802.3dj D3.0

Comment Resolution

Logic Topics

Figure 176C-3—Inter-sublayer service interfaces for a 200GAUI-1, 400GAUI-2, 800GAUI-4, or 1.6TAUI-8 C2C

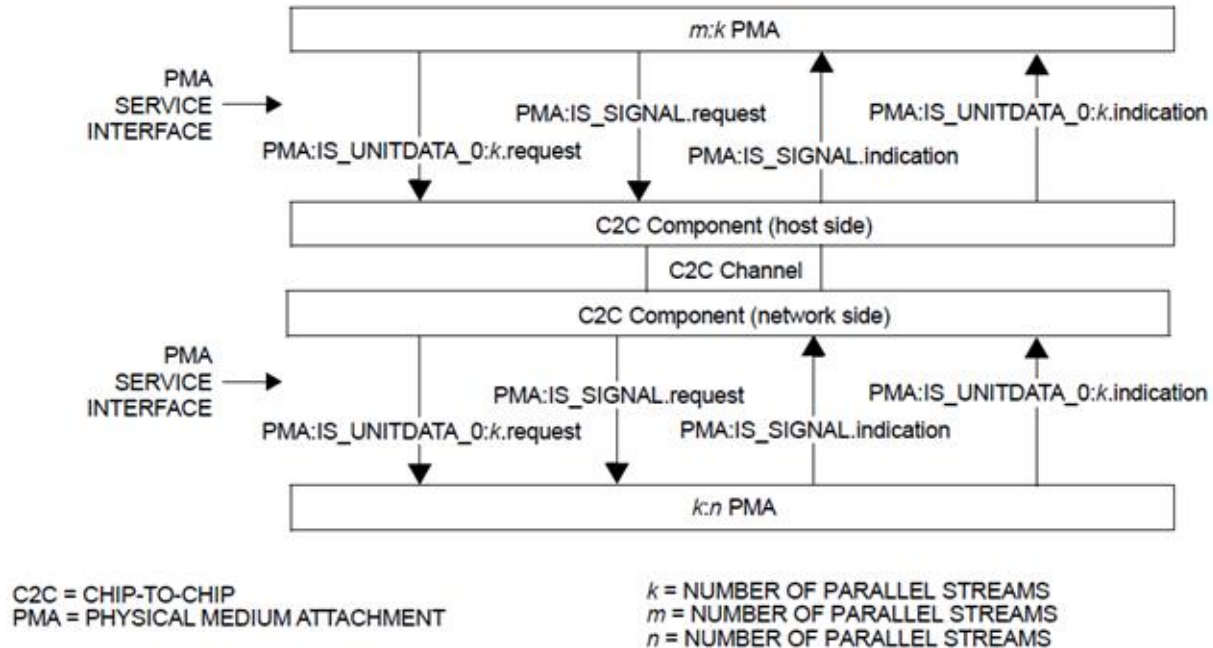
The title of this section is not entirely true as it a replica of all the registers which is more than jus the ILT training registers.

Change the title of 45.2.1.272 to be "Registers for the upper AUI component"

The proposed response to comment #365 improves the text of 45.2.1.272 so that it will read as:

Control and status registers are required for both the upper (host side) and lower (network side) AUI components (see Figure 176C-3 and Figure 176D-3). Registers 1.4000 through 1.7999 have identical functionality to the registers 1.0 through 1.3999 (address offset of 4000). The relevant registers from 1.0 through 1.3999 are used for control and status of the lower AUI component. The relevant registers from 1.4000 through 1.7999 are used for control and status of the upper AUI component. Register descriptions referring to the "PMD" should be interpreted as also referring to the "AUI".

PROPOSED ACCEPT IN PRINCIPLE.

Change the title of 45.2.1.272 to be "Registers for the upper (host side) AUI component".

"Control and status registers are required for both the upper (host side) and lower (network side) AUI components (see Figure 176C-3 and Figure 176D-3)."
